APPLICATION NO.	FILING DATE	FIRST NAMED INVENTOR	ATTORNEY DOCKET NO.	CONFIRMATION NO.
10/620,459	07/17/2003	Nobuo Suzuki	0649-0902P	9186

Office Action Summary	Application No. 10/620,459	Applicant(s) SUZUKI ET AL.	
	Examiner Chriss S. Yoder, III	Art Unit 2622

DETAILED ACTION

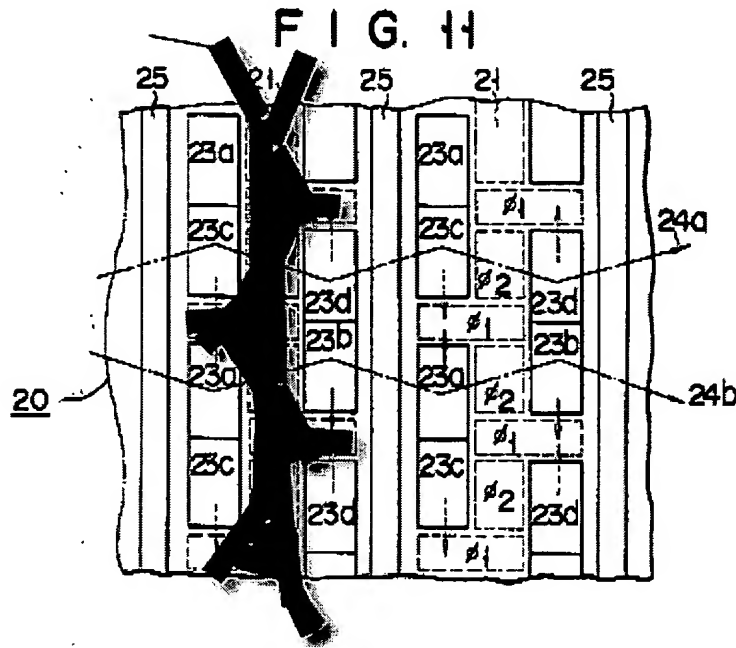
6. In regard to claim 4, note Sekine discloses the use of a solid-state image pick-up device having a plurality of photoelectric converting devices arranged in a row direction and a column direction orthogonal thereto over a surface of a semiconductor substrate (figure 11: 23), comprising a vertical transfer section for transferring a charge from the photoelectric converting device in the column direction (figure 11: 21), a horizontal transfer section for transferring a charge from the vertical transfer section in the row direction (figure 4: 26), and an output section for outputting a signal corresponding to a charge transferred through the horizontal transfer section (figure 4: 6), the vertical transfer section includes a plurality of vertical transfer channels formed on the semiconductor substrate corresponding to the photoelectric converting devices provided in the column direction, a plurality of vertical transfer electrodes formed to cross each of the vertical transfer channels as seen on a plane, and a charge reading region for reading a charge of the photoelectric converting device onto the vertical transfer channels (figure 11: the transfer channel is considered to be path 21, the transfer electrodes are only partially illustrated by $\Phi 1$ and $\Phi 2$, and the charge reading region is considered to be the arrow output from each pixel), the vertical transfer channel takes such a shape as to connect two winding shapes extended wholly in the column direction between the photoelectric converting devices (figure 11: 21 is considered to extend in both the left and right directions in a winding pattern connected at electrode $\Phi 1$; an

example can be seen below), and that the respective vertical transfer channels are shared for the transfer of the charges from two adjacent columns (figure 11: 21, $\Phi 1$ and $\Phi 2$).
